## SERVICE BULLETIN

TS-430S RECIEVER INTERNAL BEAT

1-27-84

RF UNIT (X44-1510-00)

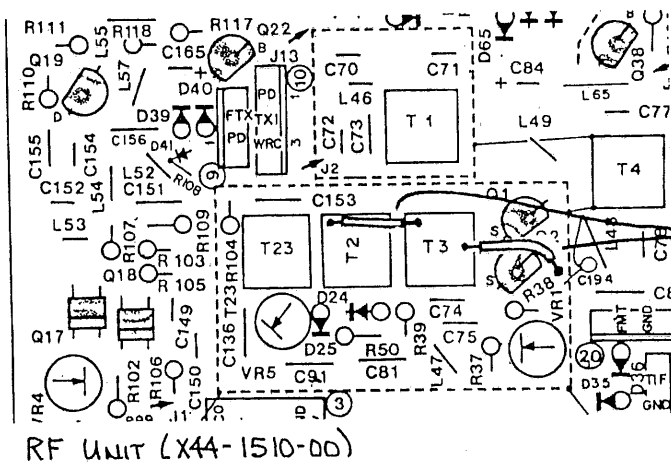
1. On the RF Unit (X44-1510-00) add a short jumper wire from the primary ground of transformer T2 to the primary ground of T3 as shown.
2. Add a jumper from the ground of the secondary of T3 to the ground side of capacitor C194, as shown.
3. Solder a jumper from the shield surrounding T1 to the shield surrounding T2, T3 etc. It may be possible to just bridge the two cases together with solder, either way is acceptable.
4. On PLL Unit (X50-1910-00) locate the position shown for capacitor C57. This capacitor was not installed at the factory, install a .01 uf 25v disc ceramic capacitor.

Add JUMPER WIRE (FDIL SIDE)

PLL UNIT (X50-1910-00)

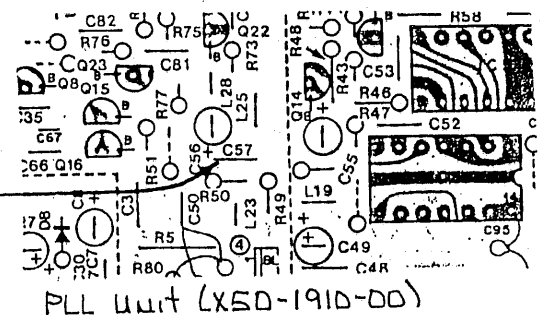
Add C57  
.01MF 25V
